TOWN OF LYSANDER
PLANNING BOARD MEETING
8220 Loop Road
Thursday, July 13, 2023 at 7:00 p.m.

SUBJECT: West Genesee Road Solar 1, LLC
1235 West Genesee Road Solar Site

SUBJECT: 3354 Cold Springs Solar, LLC
3400 Cold Springs Road Solar Site

OVERFLOW WEIR DETAIL

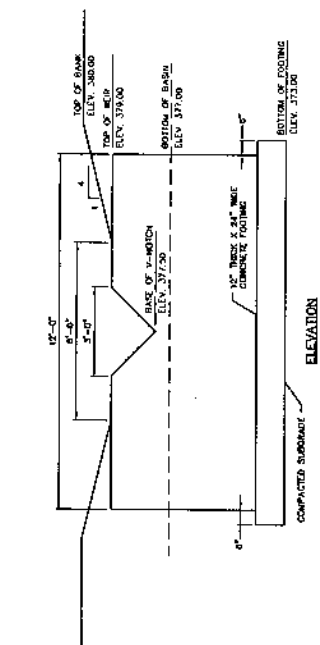
12. Grading plans and cross sections for the proposed dry stormwater ponds will need to be provided.

Response: *The revised Site Plans now include proposed grading for the stormwater "pocket ponds" and details are now included for their outlet weirs.*

CAST-IN-PLACE CONCRETE EQUIPMENT PAD - SECTION

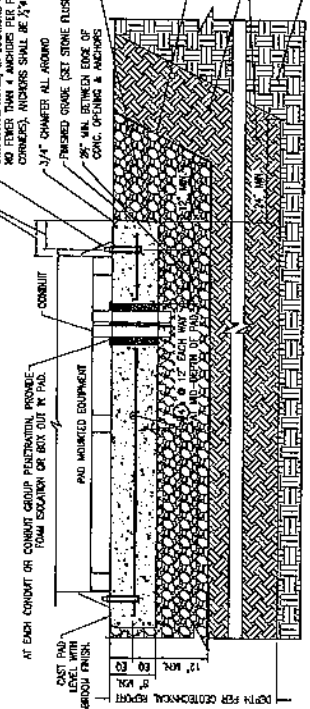
7. Details for the concrete pads the site equipment will be placed on will needs to be included in the site details.

Response: *A detail for the concrete equipment pads has been added to Sheet C-5.1.*
